MeshSat field kit V2, Option A(i) lid pack: sheet A1-1 arrangement B in plan: the lid module, the QMX set and every face part under the lid

MESHsat-1357, stream a1mech, 29 Sep 2026. Case frame: X east, Y toward the hinge (back) wall, Z up from the base floor, lid closed. mm. Prototype design, AI review: nothing built, bought or fitted; analytical success is not physical verification.

MeshSat field kit V2, Option A(i) lid pack: sheet A1-3 the arrangements that fit, and the owner decision

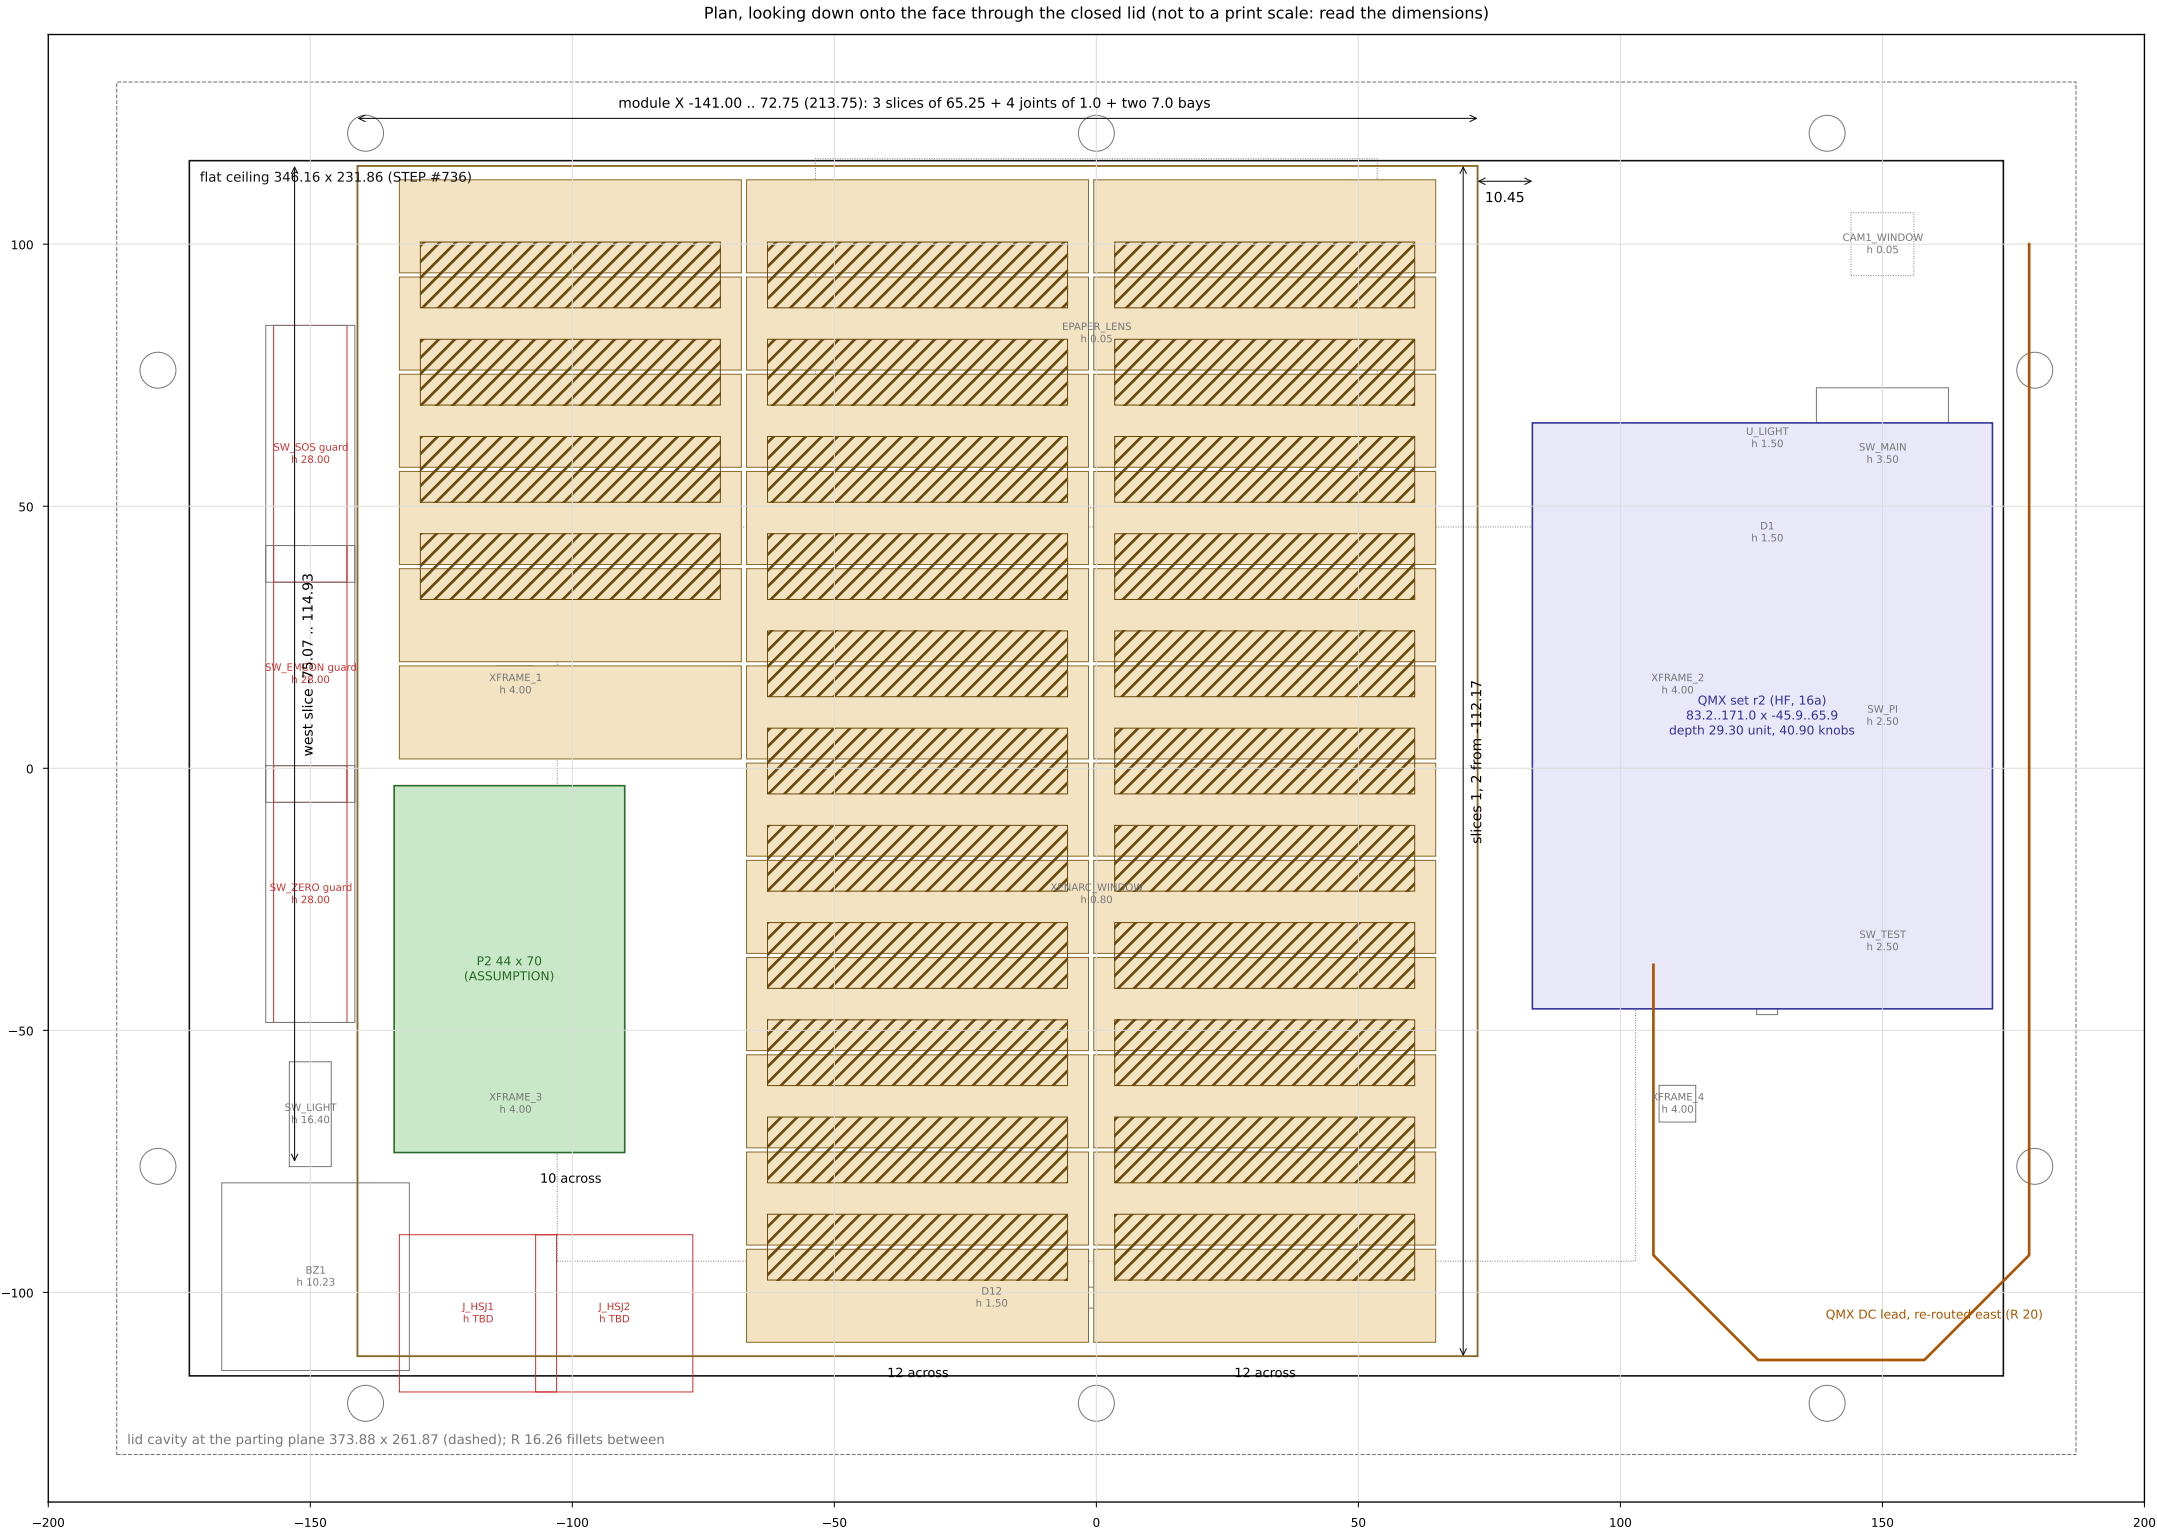
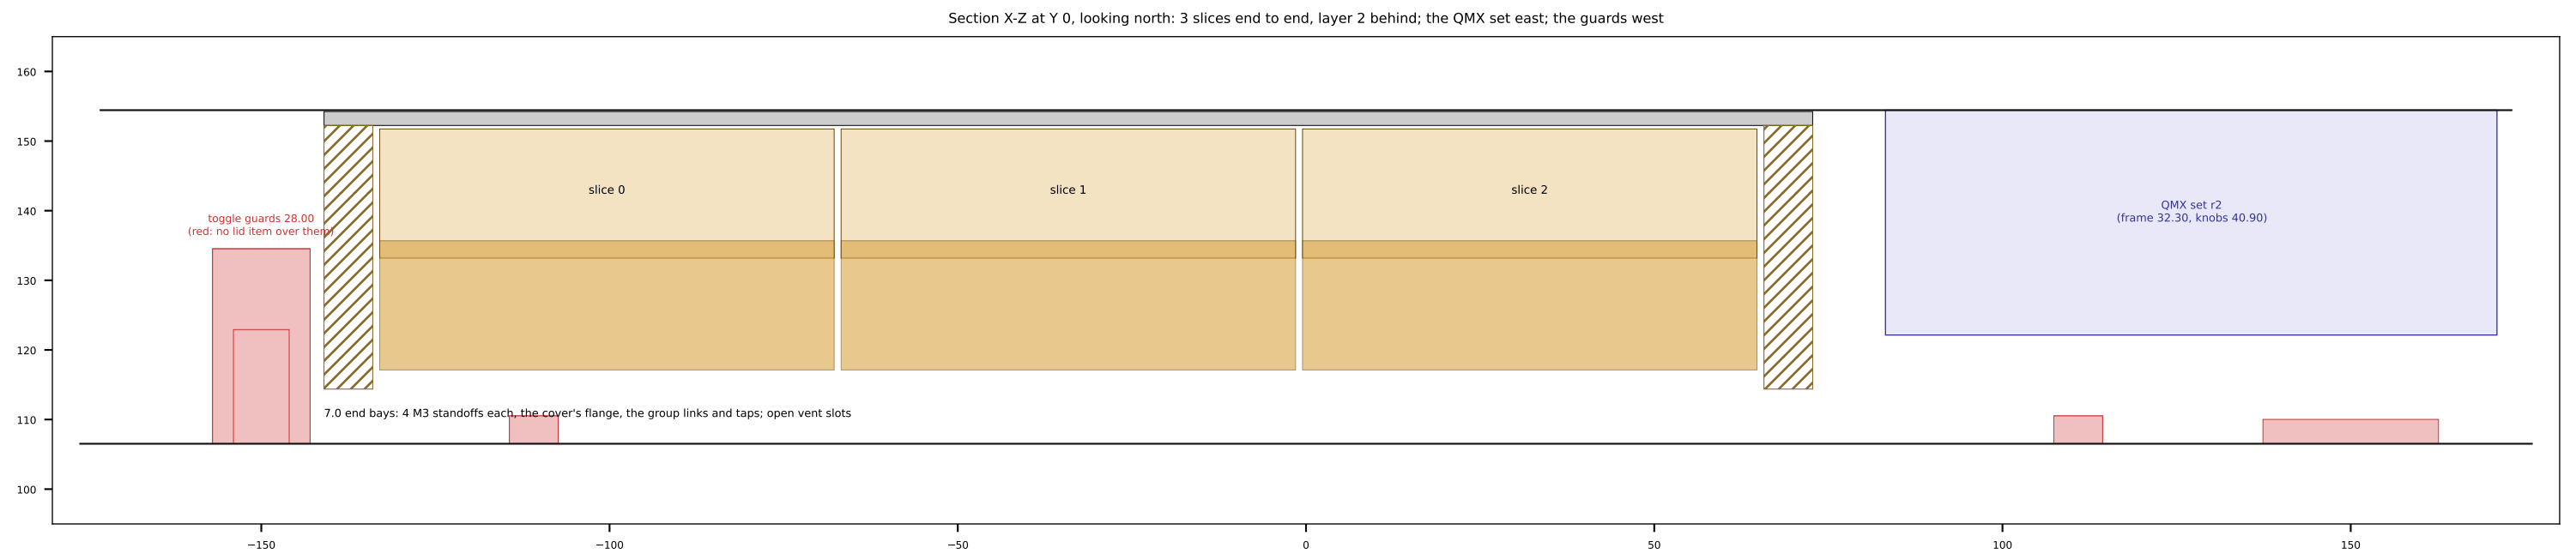
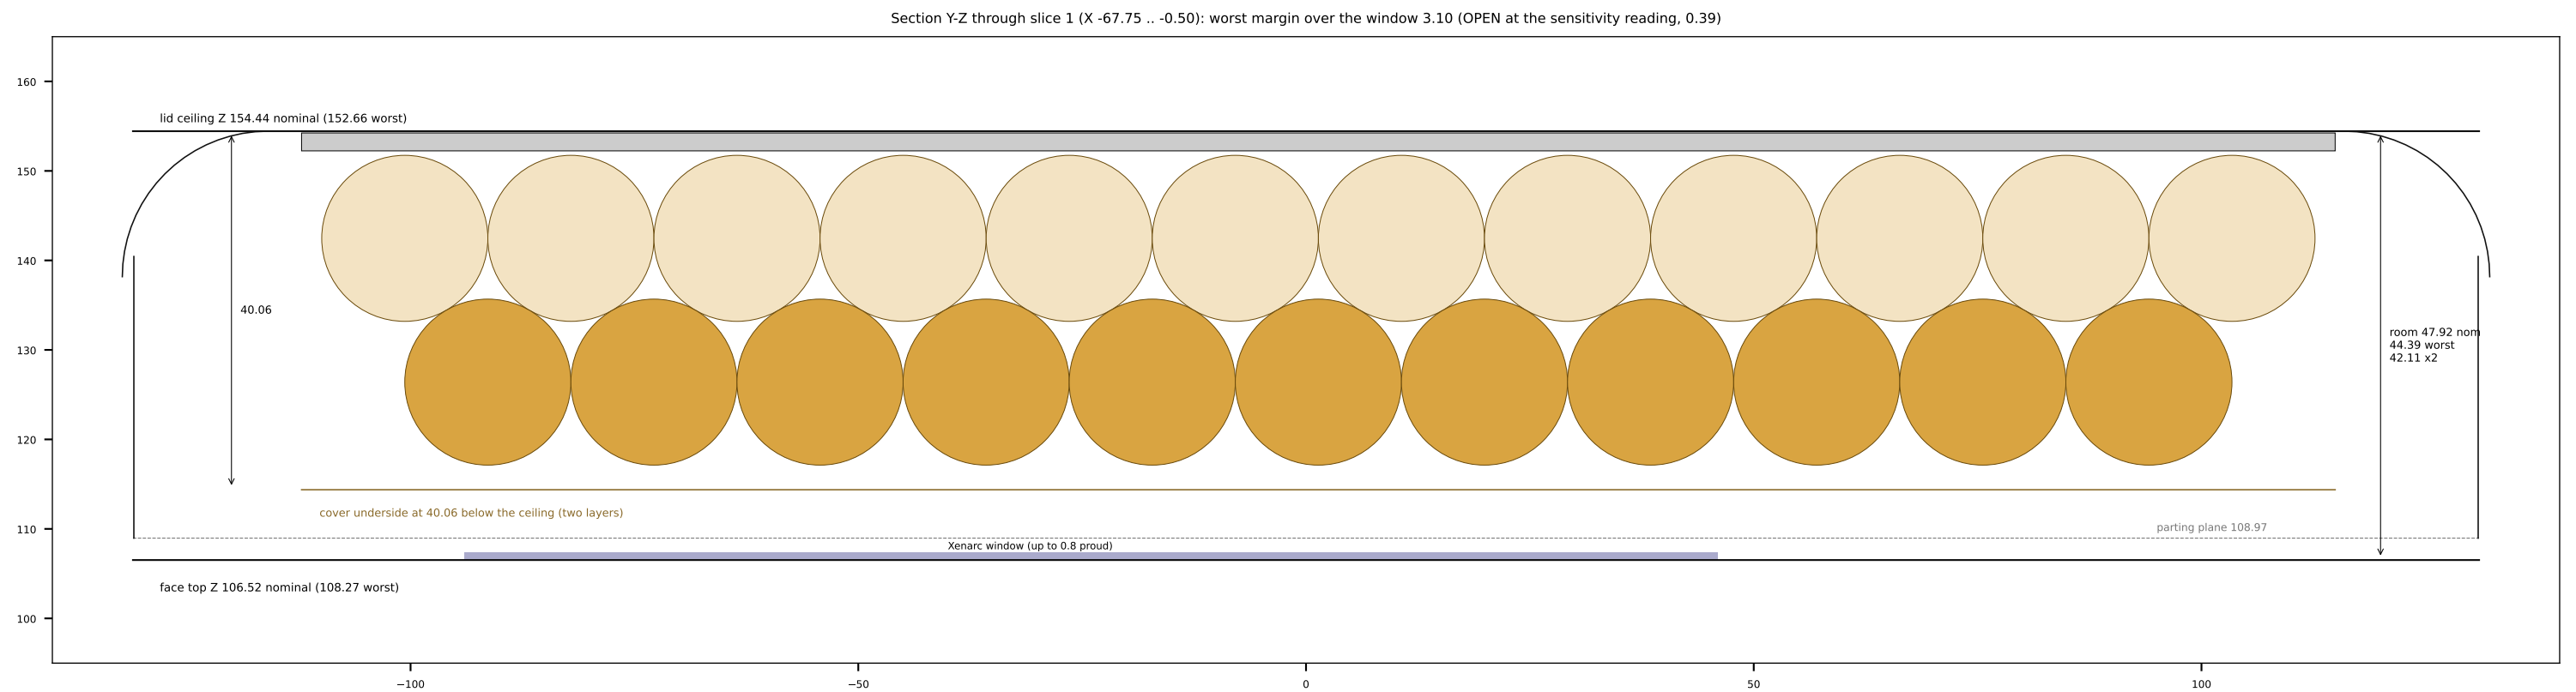
TIGHTEST ROWS (worst, x2; min 1.0)
two layers over the Xenarc window 0.80: 3.10, 0.39 OPEN
two layers over the LED bar 1.50: 2.40, -0.31 OPEN
two layers over the e-paper lens: 3.85, 1.14 MET
one layer over the XFRAME screws: 15.96, 13.25 MET
layer 2 refused over XFRAME_1 and _3 (4.00): -0.10 worst

OPEN AT THE MOCK-UP: T9 (chalk on the module's cover and the
face parts, lid closed), T8 (pull test of a bonded plate on
Peli's polypropylene), T-A1-1 to T-A1-4 of the README.

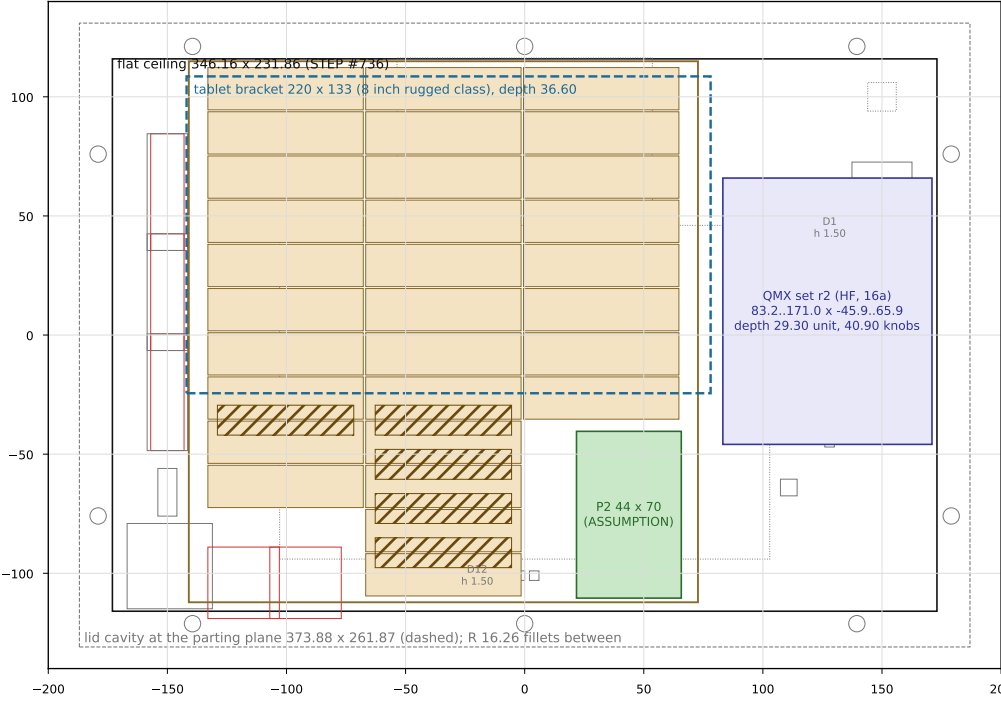
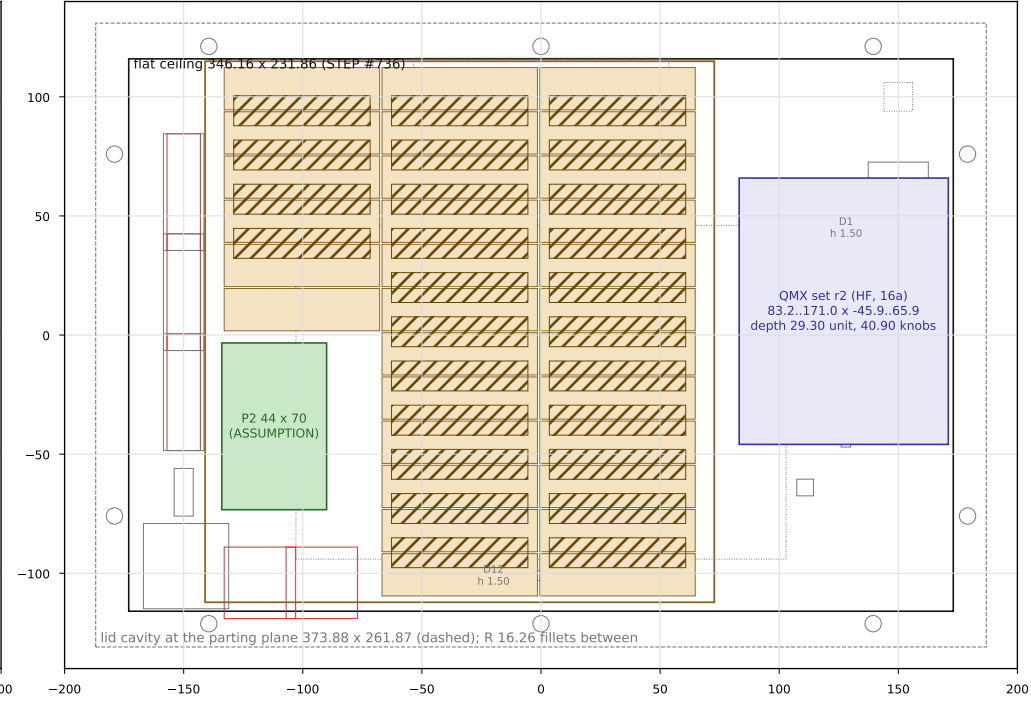
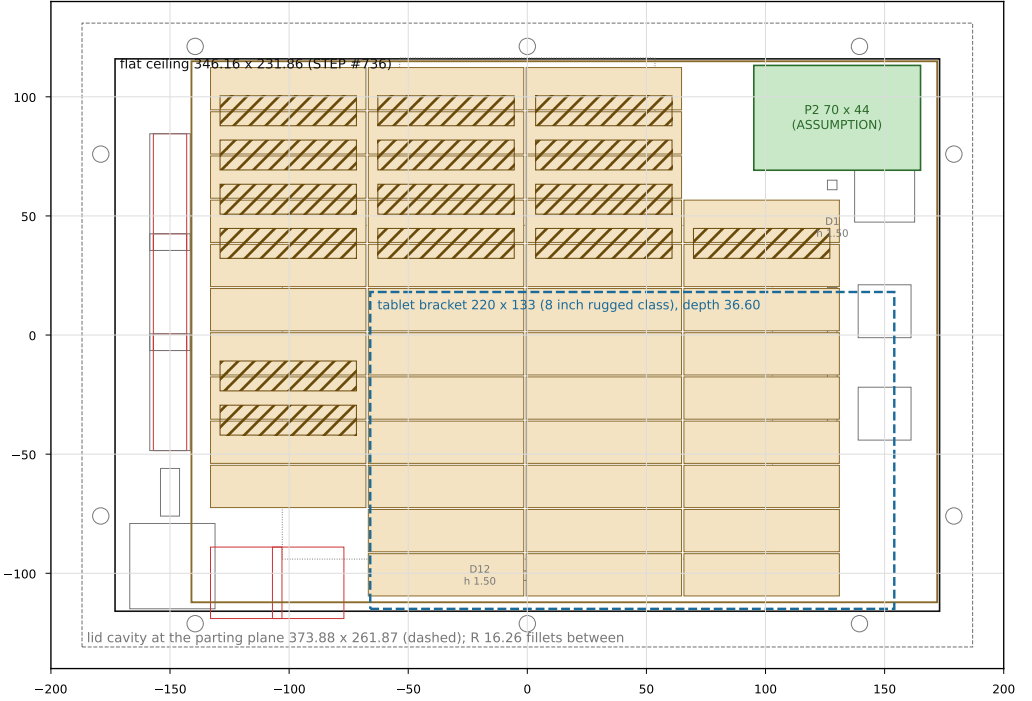
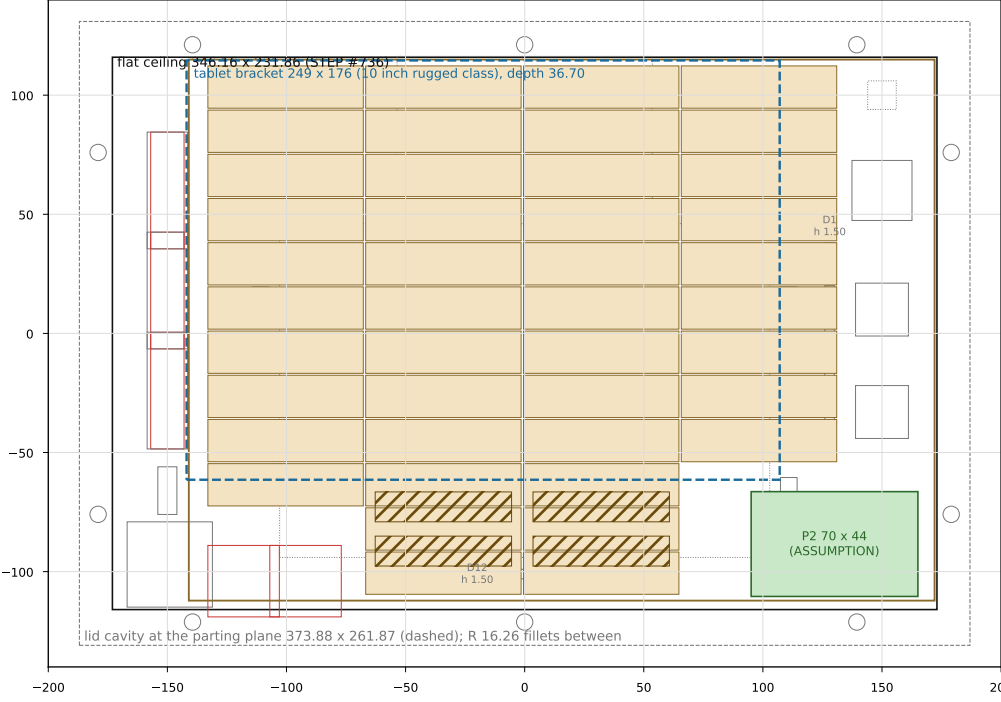
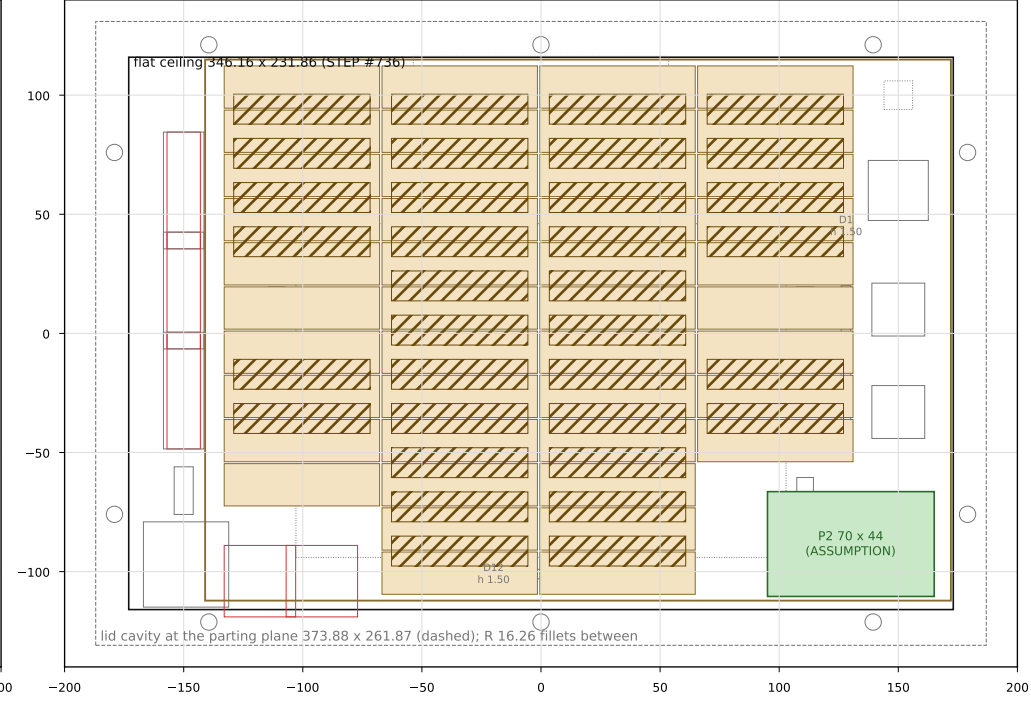
48 cells (4S12P) in the lid with BOTH the QMX HF set (16a) and the tablet bracket (16d): DOES NOT FIT. At the worst room the lid holds 35 places with both, 4S8P; the total 4S14P is under section 9c's 4S15P floor.

What fits 4S12P (each with every row of sheet A1-1 at or above its minimum at the worst):
1. HF kept, tablet bracket out of the lid: 56 places (4S14P); the tablet goes out of the case.
2. 8 inch tablet kept, HF (QMX) out of the lid: 58 places (4S14P); HF inside (16a) is lost: the base has no volume for the QMX set (section 8)
3. Both kept, lid pack 4S8P: not Option A(i); M1 not met on section 9's model

Session's recommendation (engineering view only): option 1, which keeps a radio bearer and gives 8 spare places; the tablet works from outside the case on the kit's WiFi and USB-C outlet.
